HISE RESIDENCE

SHEET NAME
ELEVATIONS
SHEET #
A1

APPROVED
Limited building only review
Permit holder responsible for full compliance with the code

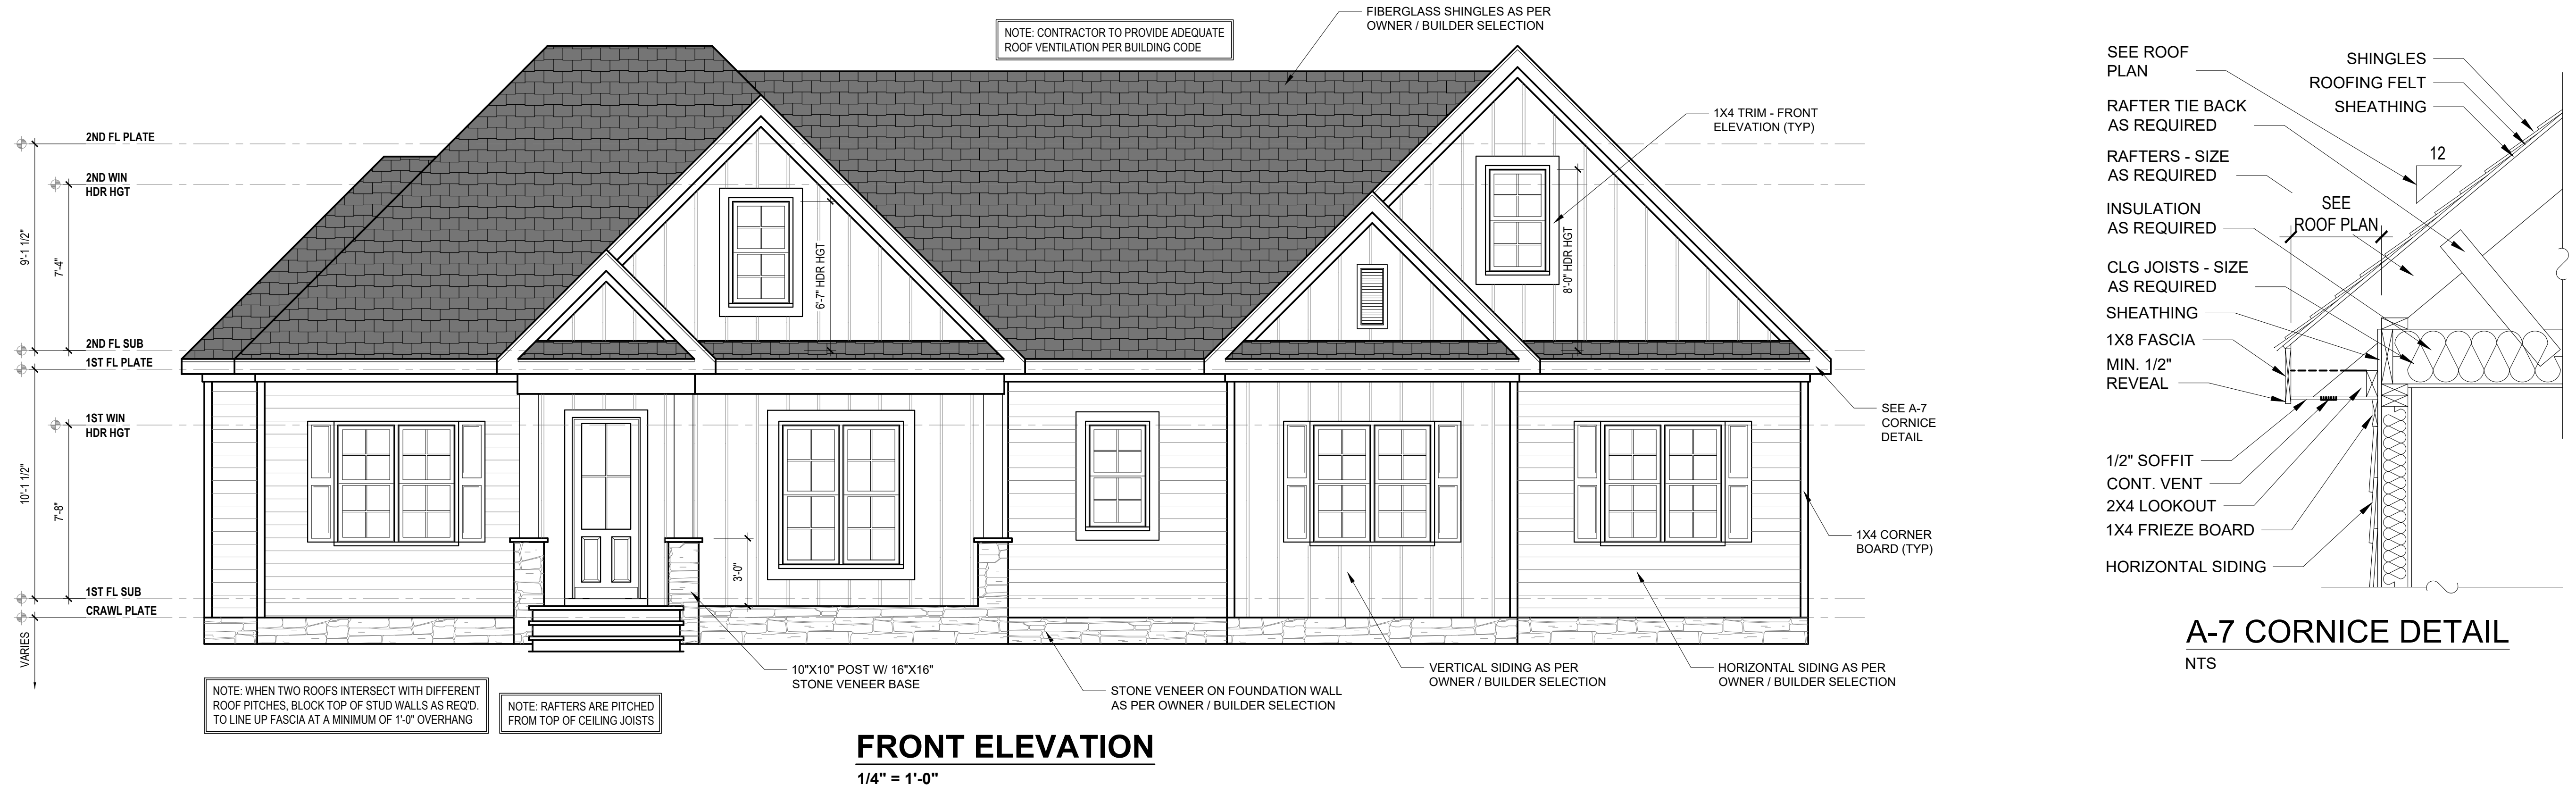
See notes on second floor floor plan

SECOND FLOOR PLAN
1/4" = 1'-0" CEILING HGT. = 9'-0"

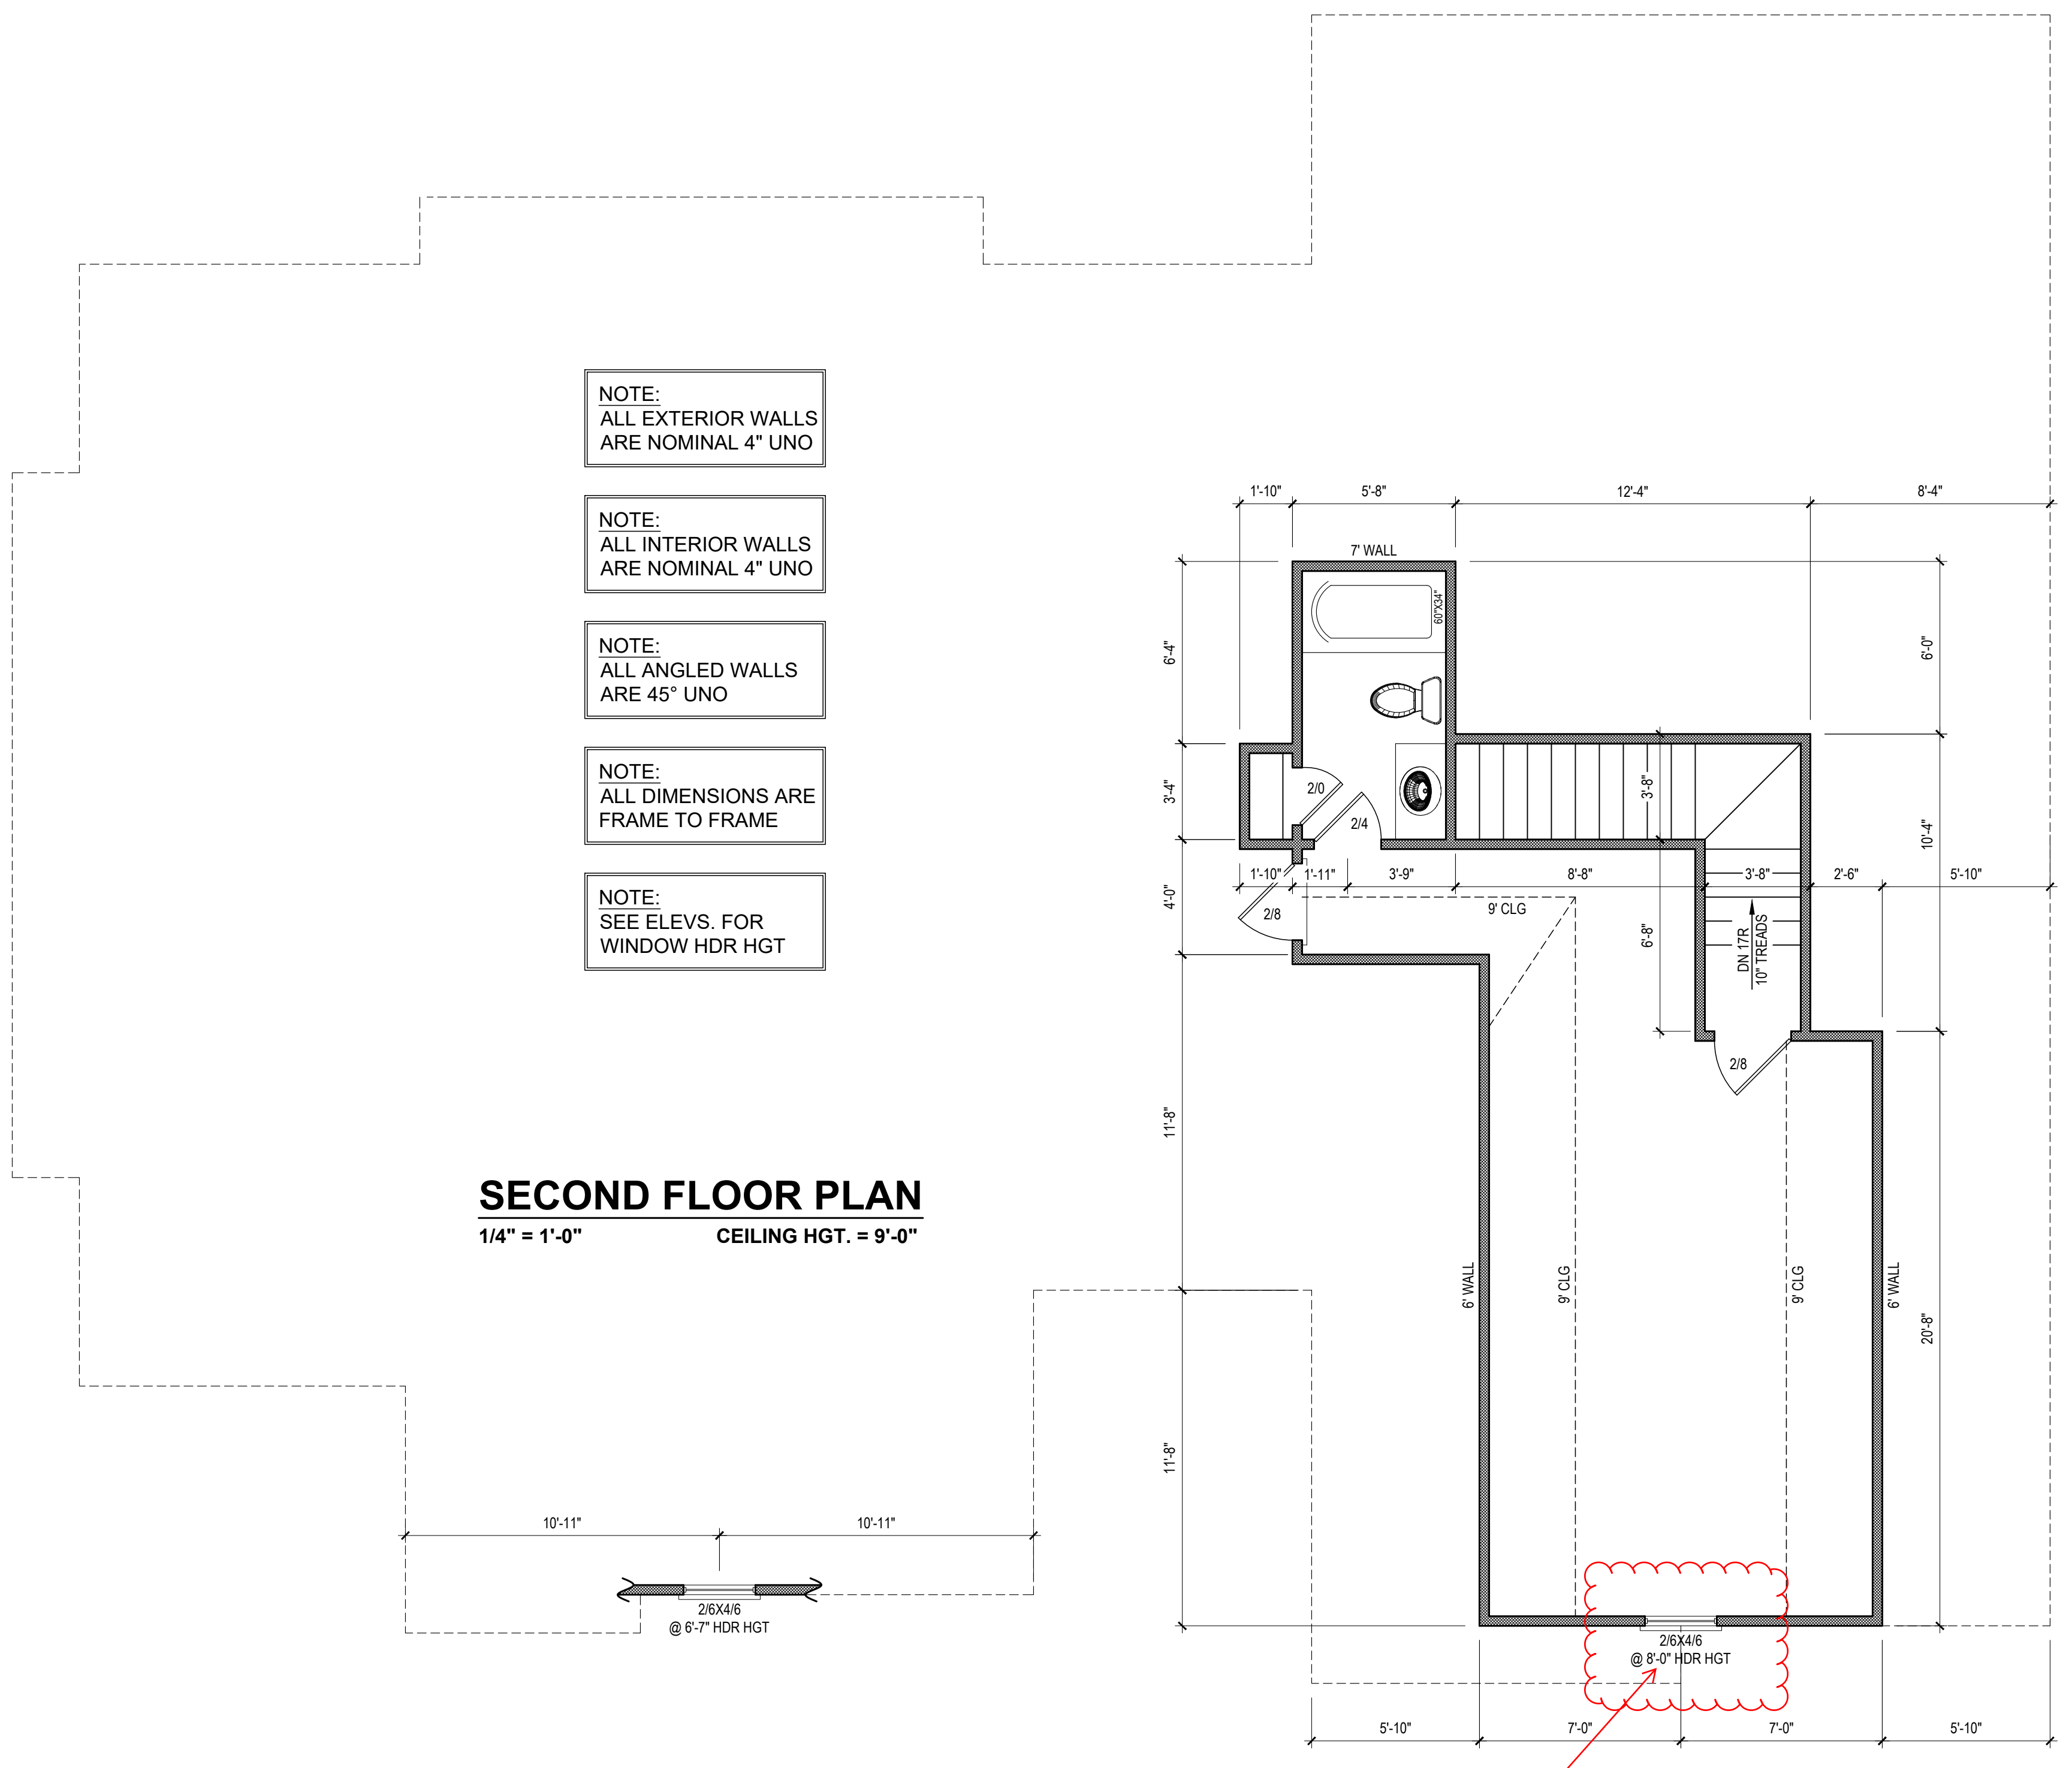
This window must meet minimum egress requirements
